## REMARKS

The claims before the Examiner are directed toward a non-volatile memory device for storing both code and data. While the device is programming or erasing its nonvolatile memory, if a host system sends the device a read request, hardware such as one or more logic circuits in the device signals the host to delay executing the request while the device suspends the programming/erasing. Then the hardware suspends the programming/erasing and signals the host to execute the read request. When all read requests have concluded, the hardware resumes the programming/erasing.

FIGURE 1 (PRIOR ART)

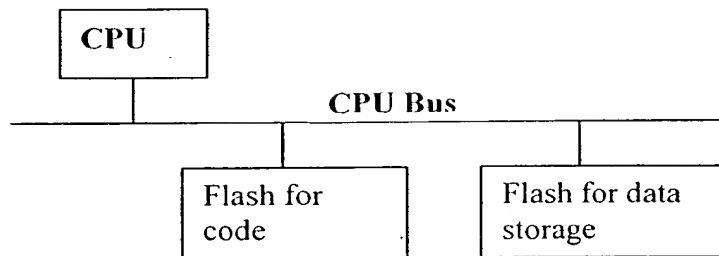
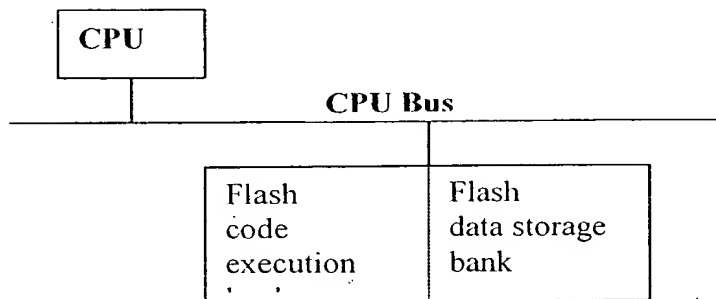
The Examiner has objected to Figure 1 for lacking a legend such as “PRIOR ART” to indicate that only prior art is illustrated. Attached please find a replacement drawing in which both Figure 1 and Figure 2 are labeled as PRIOR ART in red.
